Proposed
Amendments to the
Seton Ridge DA

Case 23746 & 22896

Feb 8, 2022

1. Case 23746: Amend Map 9Df of the Halifax MPS to remove a walkway to Bayview Road
2. Case 22896: Amend the DA to improve clarity for the developer moving forward.

Bedford Highway Secondary Planning Strategy
Map 9Df – Seton Ridge Neighbourhood Plan

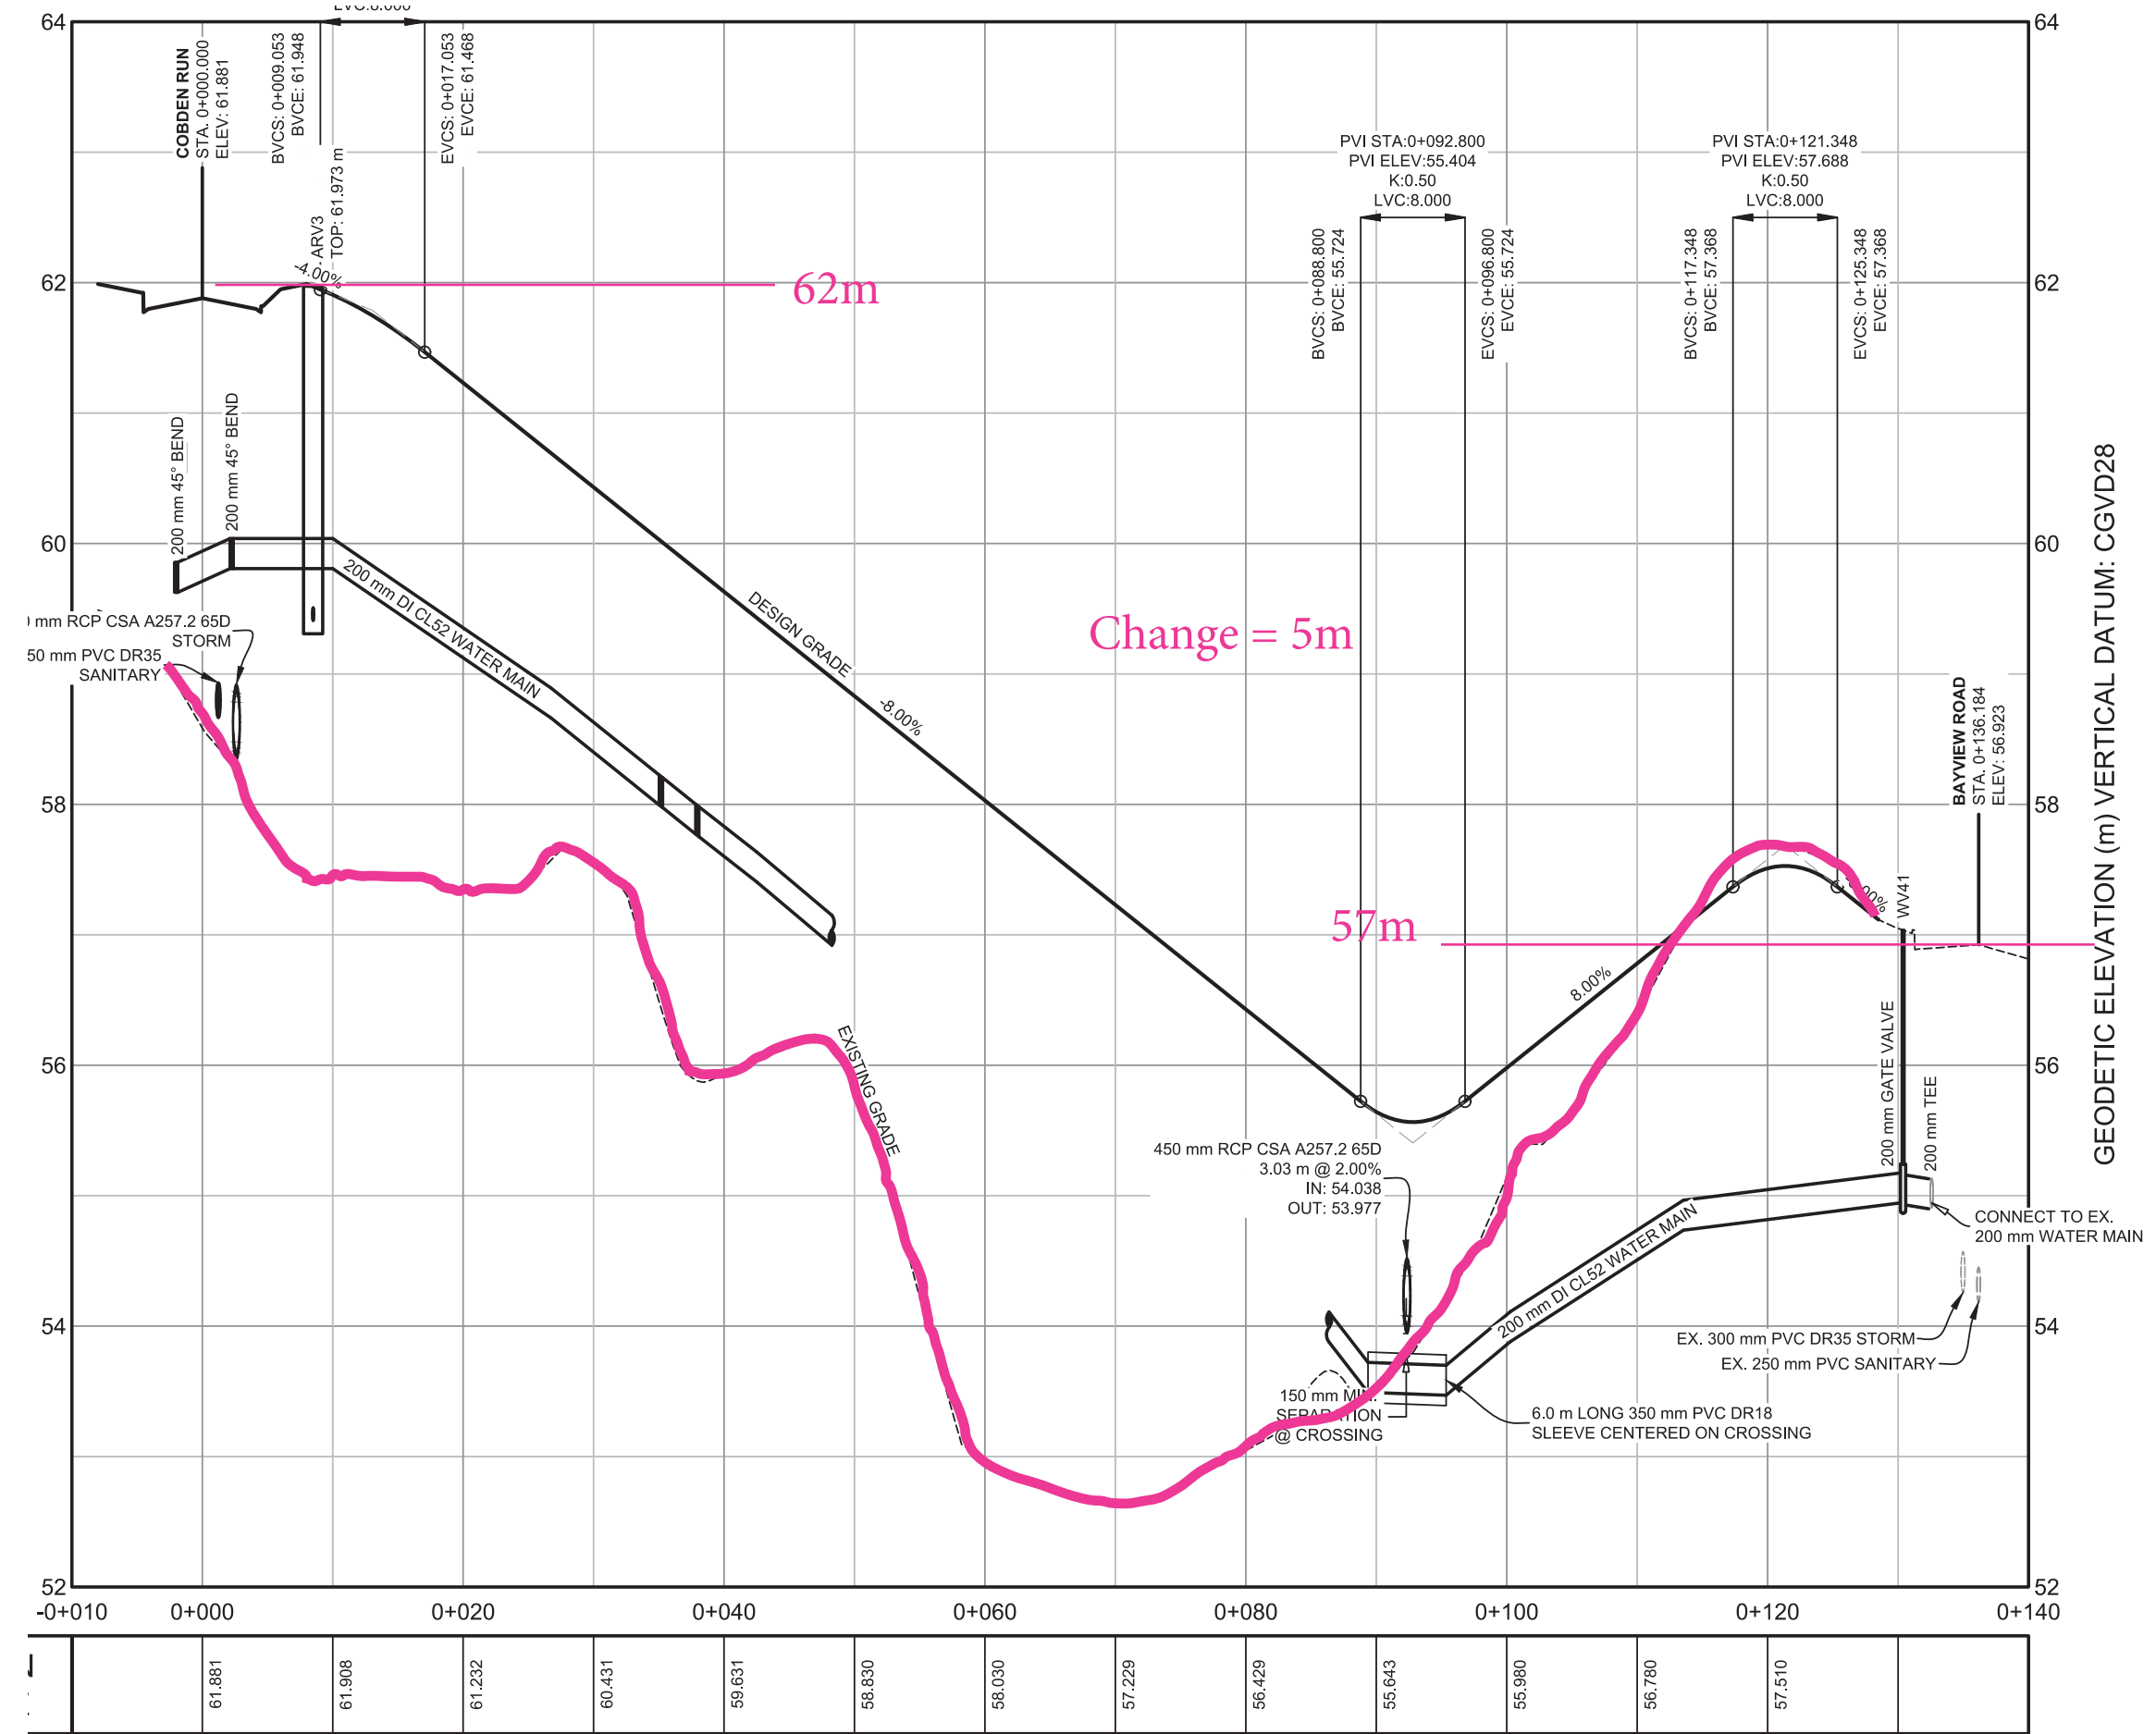
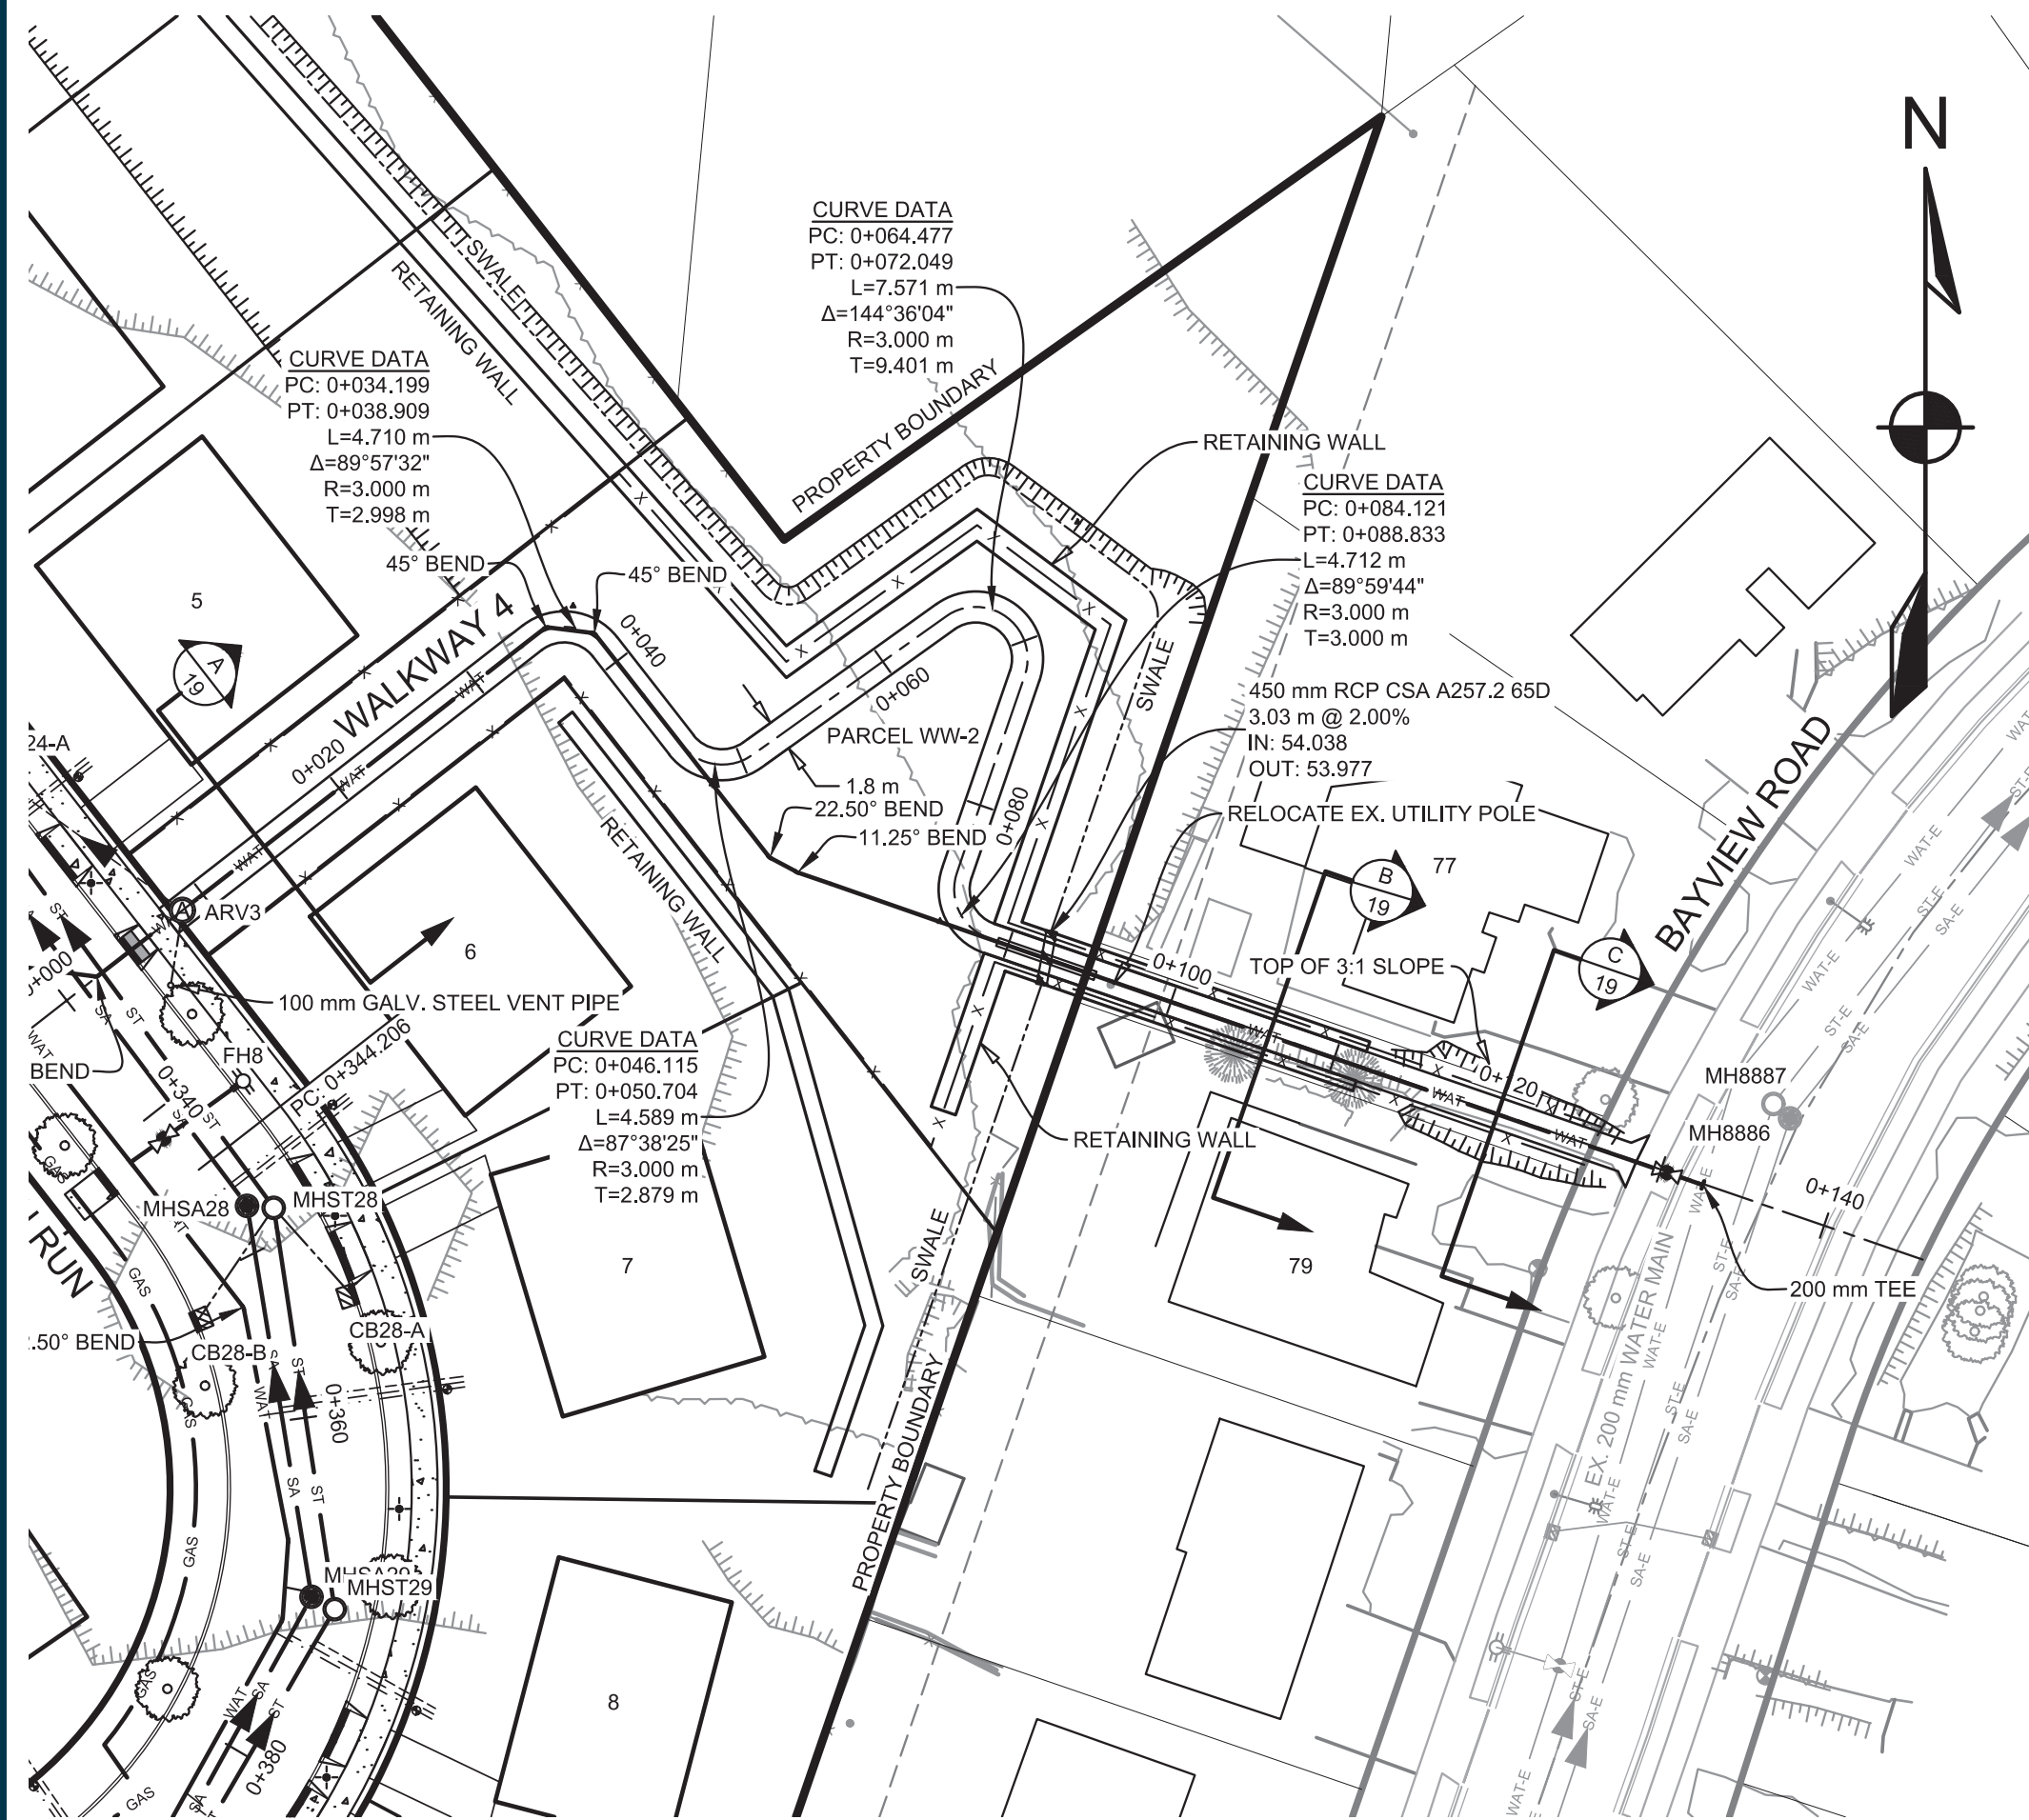
- MPS Policies were added to guide the SETON RIDGE NEIGHBOURHOOD PLAN.
- This map included a walkway connection between Seton Ridge and Bayview Drive.
- The 12' trail easement was put in when Bayview Drive was built.
- The 6m vertical grade change will not accommodate a path slope or width that would be acceptable to HRM
- A walkway cannot physically be built to meet HRM standards in this location and the large retaining walls required would be detrimental to the abutting residential properties on either side
